COMMENTS ON SUBMISSIONS DEADLINE 6. PHILIP WATSON

Extinguishment of rights at Tadcaster East CSEC

NATIONAL GRID
 (YORKSHIRE GREEN ENERGY ENABLEMENT PROJECT)
 ILLUSTRATIVE PLAN: A659 ACCESS - TADCASTER
 REGULATION 5(2)(o)
 SHEET 1 OF 1

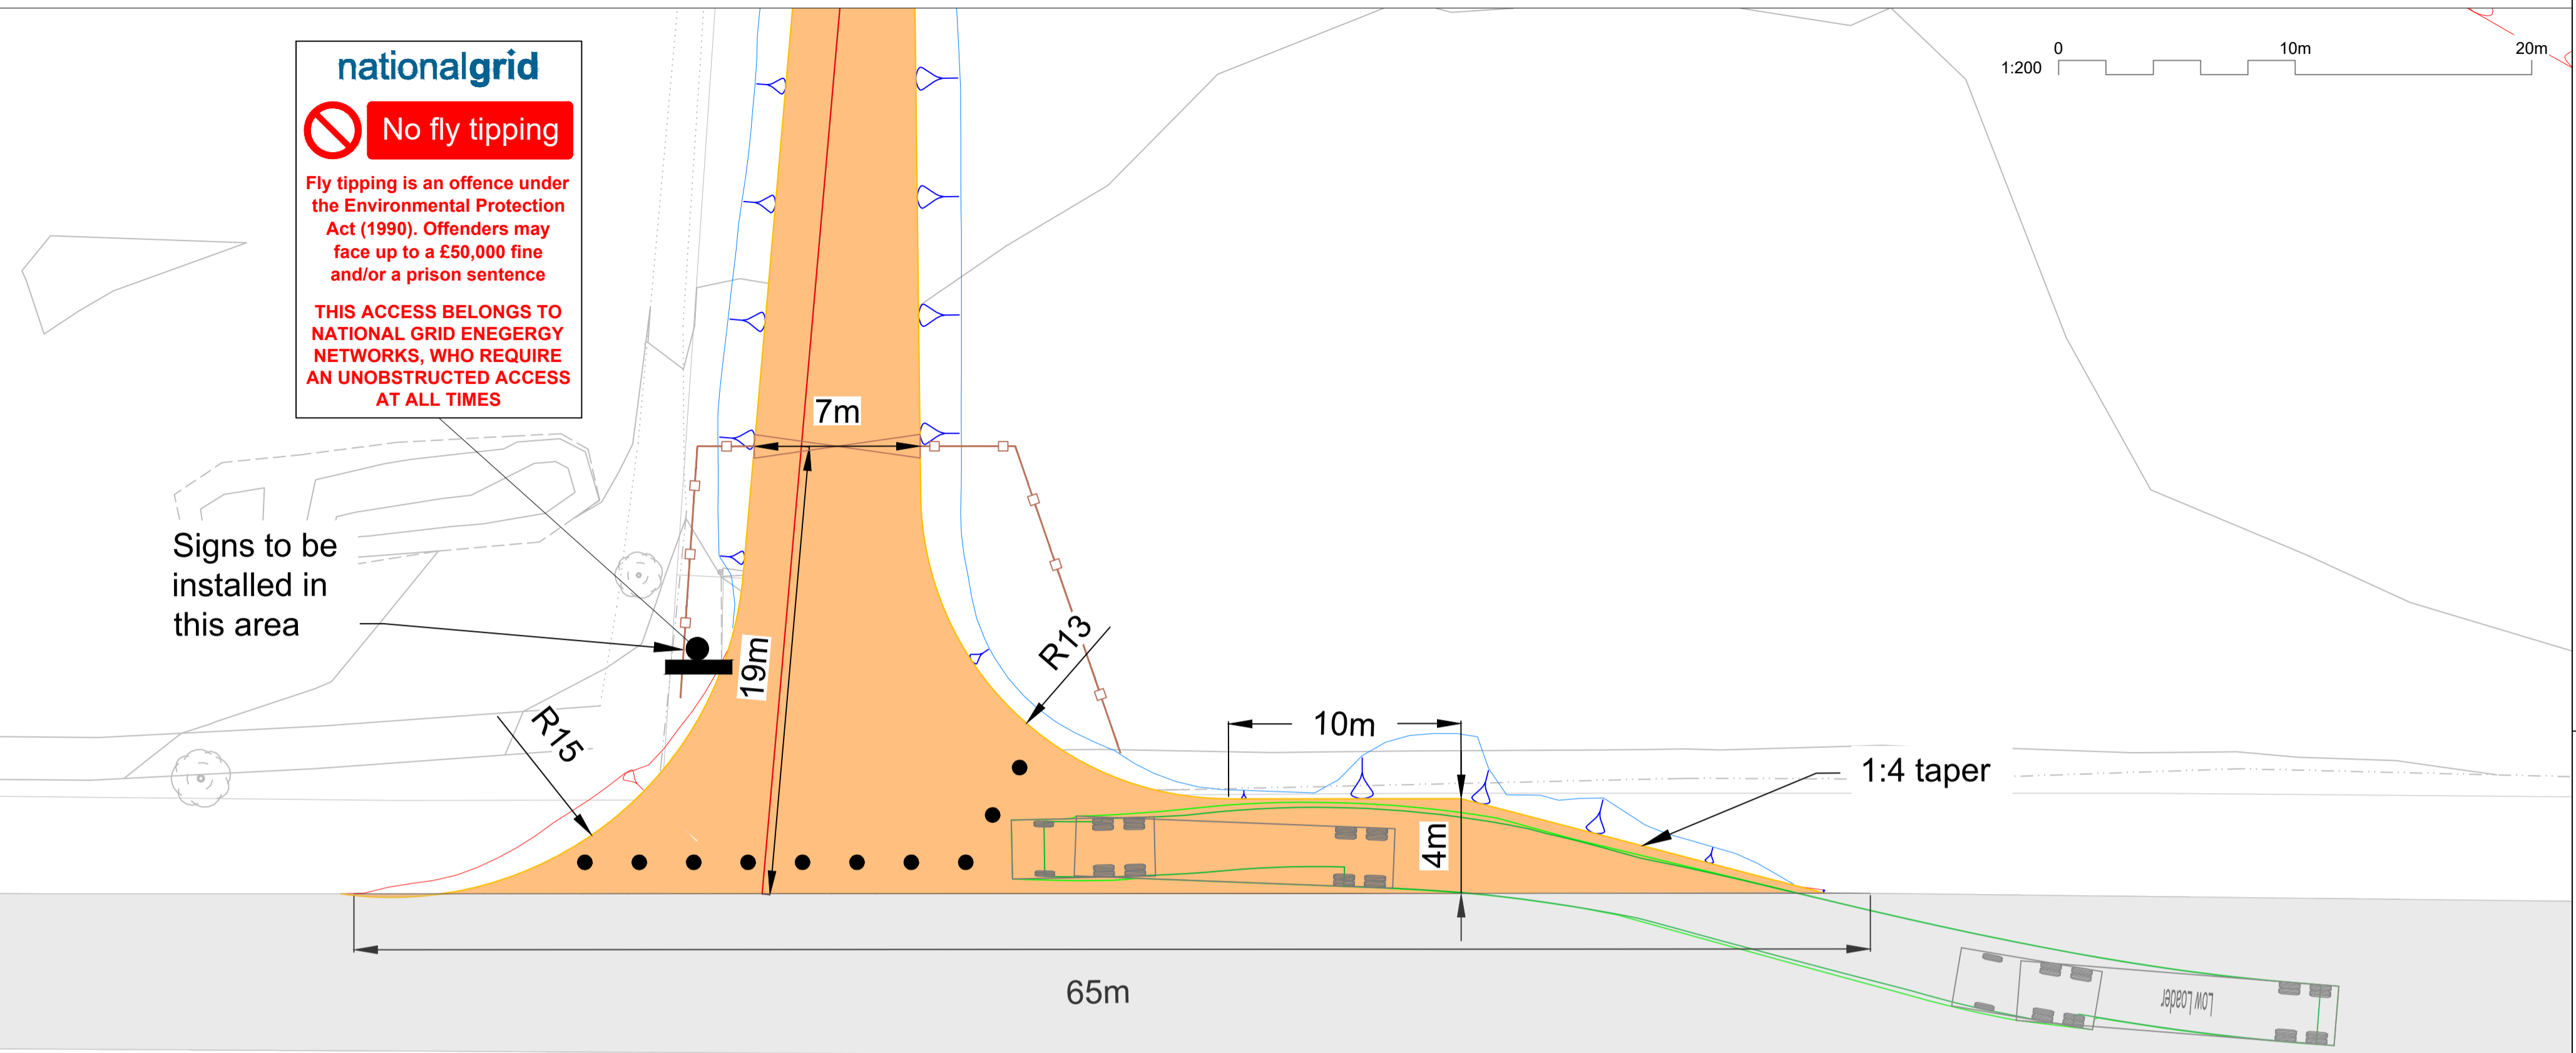
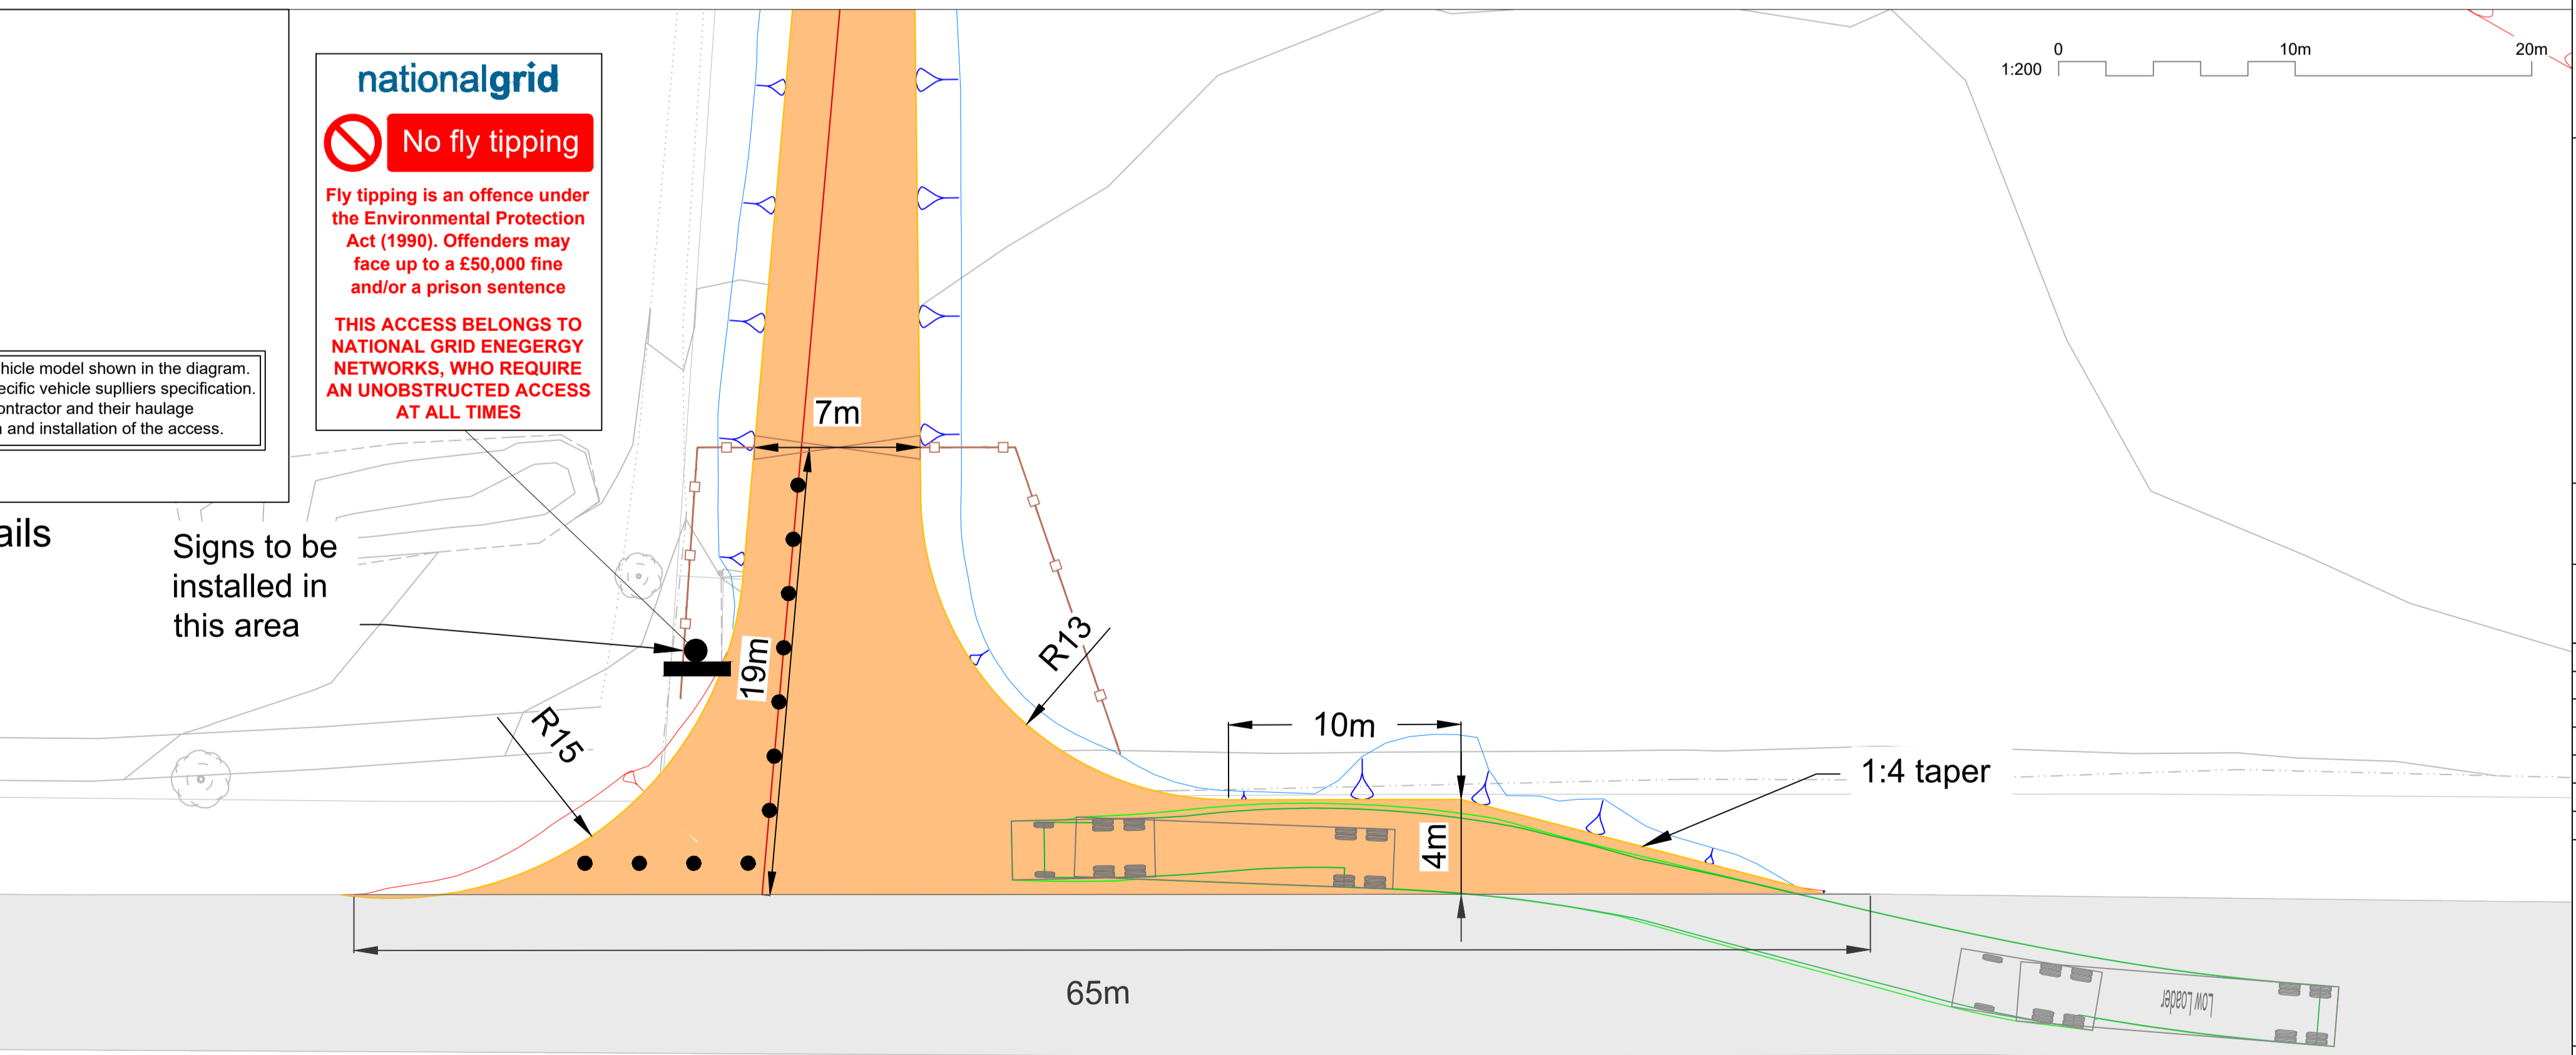
I have recently received some details from National Grid (please see A659 Access- Tadcaster in the file attached). I understood at the CAH2 meeting that National Grid would be happy to reduce the access road into my field from 7 metres to 4 metres but they have clearly failed to do this in the attached plan. The plan still shows a road into my field 7 metres wide. They also said this would have an impact on the bellmouth and the width would be reduced. I don't think it has though. Clearly National Grid have created a parking area large enough for an articulated lorry. It seems very obvious to me that it would be free of any obstructions and any vehicle would be able to park in this area whether it is connected with National Grid or otherwise. We seem to be talking about a bellmouth some 65 metres wide which is 5 times wider than the existing entrance. The wider this area is the more chance there will be of unwanted visitors. National Grid claim that they want to own this land in order to maintain visibility for vehicles exiting the site. They are going to do the complete opposite. Any vehicle can park in the area occupied by the articulated lorry in question and block the view of anyone wishing to leave the site. There is a serious safety issue here if this happens and because it is a 60 MPH road the potential for a serious collision with oncoming traffic due to reduced visibility will be high if any vehicle parks in this area. A no parking sign is hardly going to deter anyone parking here. National Grid clearly recognise this otherwise they would not have suggested bollards in the entrance.

It seems that National Grid have created an area so that any vehicle can park in the area to the right (Leeds side) and access the site. I presume that National Grid are expecting to approach from the Leeds side looking at the plan. However, my farmhouse is situated to the left (Tadcaster side) so I will be accessing the site from the left. I will have to park on the roadside and get out of my car in the road to then unlock the posts. This will be highly dangerous to both myself and other road users. Upon leaving the site I will have to park on the opposite side of the road and cross the road to lock the posts up. It won't simply be a matter of driving in with a tractor and picking up a boulder with the tractor in one movement as I do at the moment.

I am not sure what the solution could be here but I need to maintain my access point in that corner of the field off the A659 without issues and be in sole control of it as I am now. Perhaps National Grid could have a separate access point onto the brewery land to the

North of my field? They could then access both the pylon and CSEC West. Obviously moving CSEC West to pylon XD002 would solve a lot of problems.

TADCASTER ECSECC ACCESS ROAD BETWEEN COMPOUND AND FENCE LINE SHEET 2 OF 3

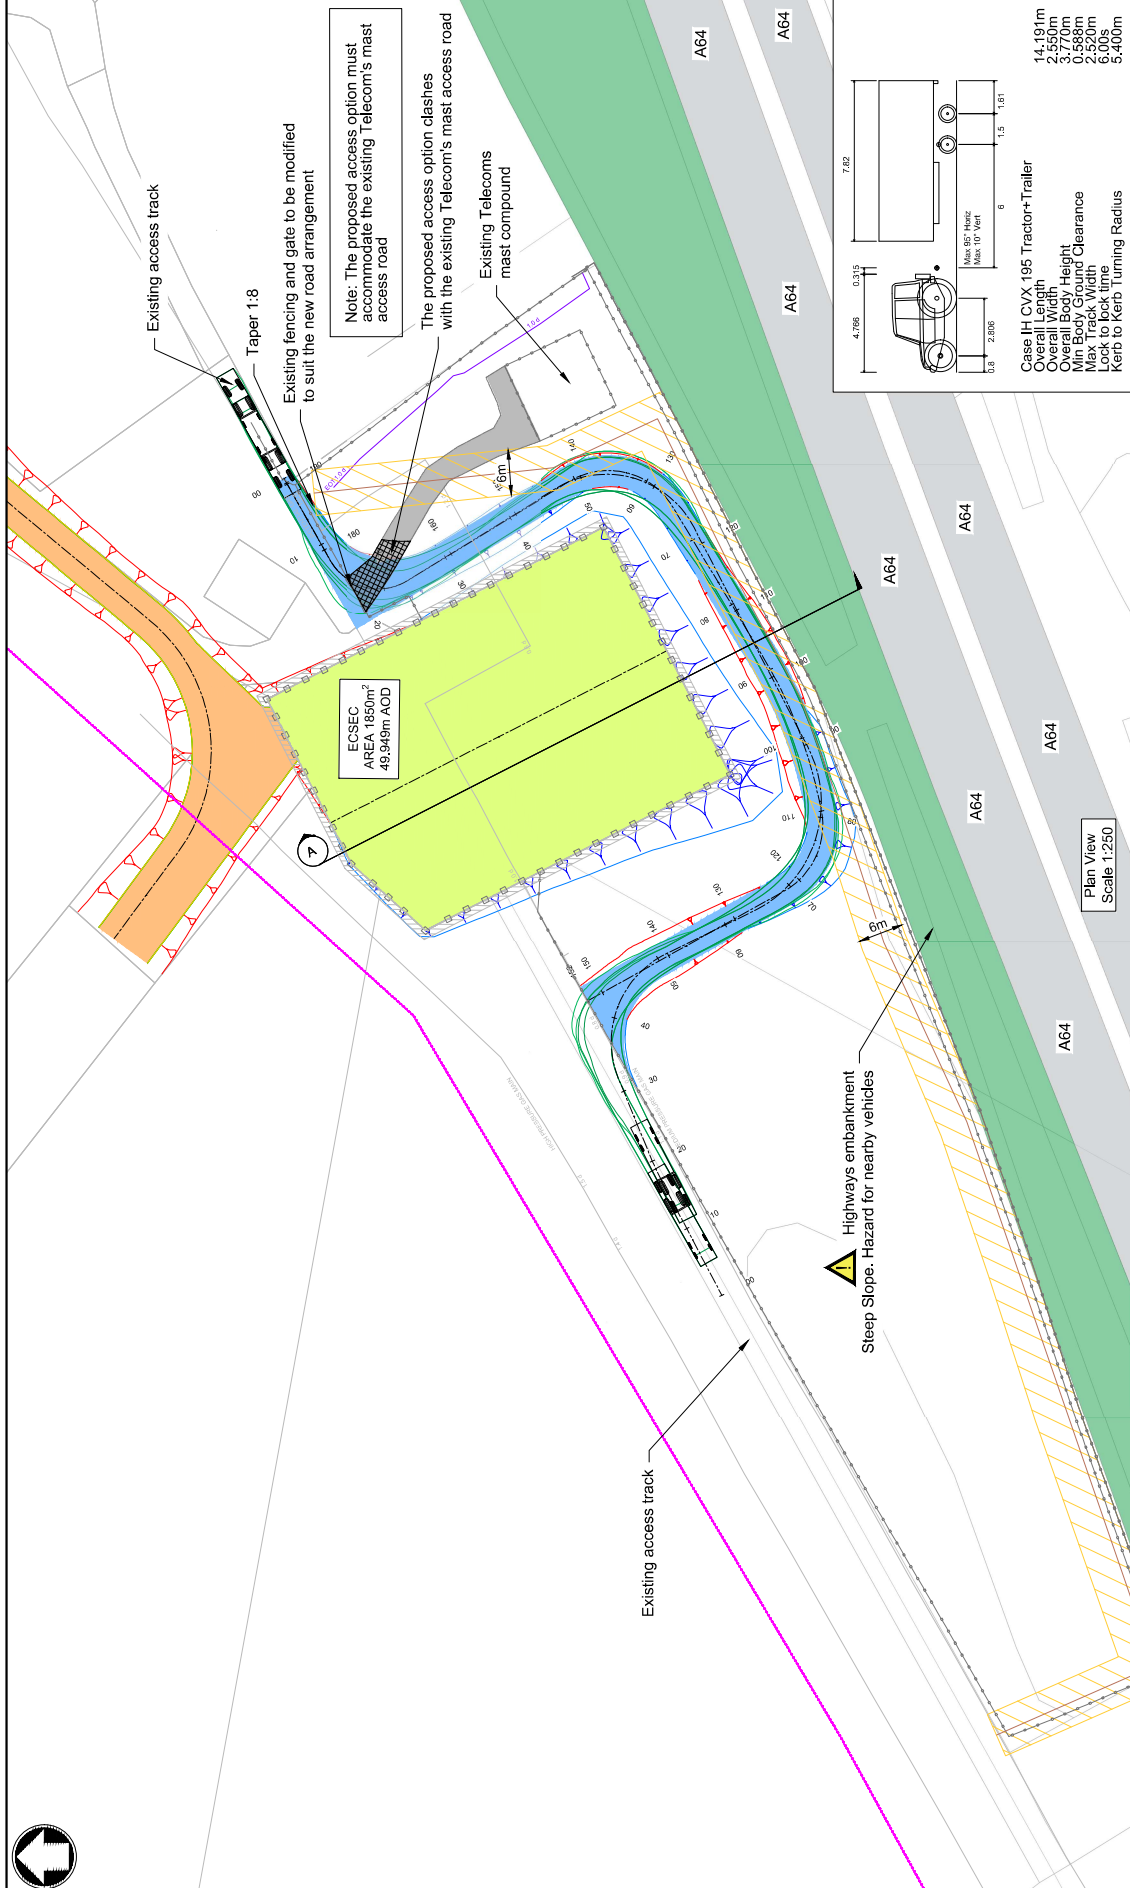
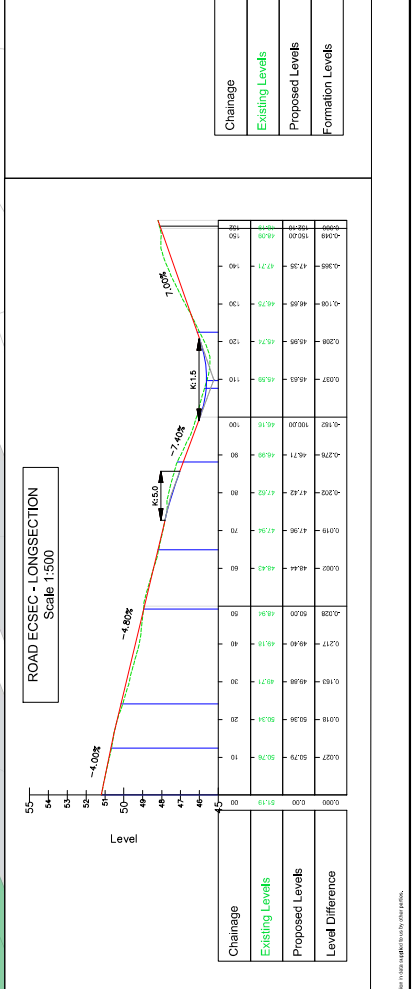
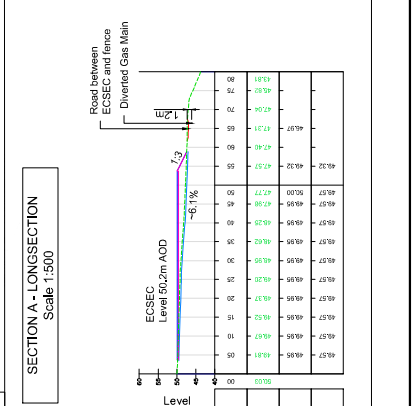
The statement in the written summary at the CAH2 meeting National Grid states that "there is a maximum of 3.7 metres between the edge of the embankment and the fence line". This is blatantly untrue and National Grid are trying to shift the evidence in order to defeat the right of way. I asked for clarification from National Grid on this who sent me a plan (see the "3.7 METRE GAP" file that is attached). This is measured from the edge of the earthworks to a piece of rabbit proof fencing recently erected by Mr Ingham. This is nonsense as the boundary is marked by the post and rail fencing and National Grid are fully aware of that. The gap then widens considerably after that. Even by this plan to say that there is a maximum of 3.7 metres is untrue as the gap widens considerably the further East that you go. Furthermore, it contradicts with all the other measurements submitted previously. Please see the "Annex b Rep5-084" file that is attached. This was taken from REP 5 -084 and I am using it because it shows the swept path analysis of an agricultural vehicle. Please note that running alongside the boundary line shaded yellow is a 6 metre strip for laying the new gas pipe. It is clearly marked as being 6 metres wide. Please also note that at the narrowest point on the western side of the CSEC there is a further gap of some 2 metres between the yellow shaded area and the blue line showing the edge of the embankment. It can therefore be extrapolated from this that at it's narrowest point there is an 8 metre gap between the embankment and the fence line. At the eastern end the area widens considerably and there appears double the width of the yellow shaded area which will be 12 metres. There clearly is enough room to put in an access road for agricultural vehicles. National Grid have already proved it.

Northern Gas Networks have previously stated that they need a minimum of 6 metres to put a new gas pipe in. If there really is going to be only a maximum of 3.7 metres then surely the CSEC should be moved elsewhere because there is not enough room to install the pipe. I have not seen any approval from Northern Gas Networks yet. Even they do National Grid have clearly demonstrated that there is between 8-12 metres of land available.

If the planning inspectorate has no issues with the constraints put forward by National Grid and does not feel able to propose a retaining wall solution then a right of way could be placed over the area left after the earthworks are put in place. At its narrowest it is 8 metres wide and goes to 12 metres at the widest position. This is ample space to put a right of way for agricultural vehicles only. See Annex B. Again, National Grid should have to purchase enough land in order provide a new right of way and not leave me in the same position when the pylon XC481 was placed over the right of way, leaving court action with Mr Ingham as the only option. This option is against my best interests as it limits the right of way to agricultural vehicles only, but it is considerably better than extinguishing the right of way.
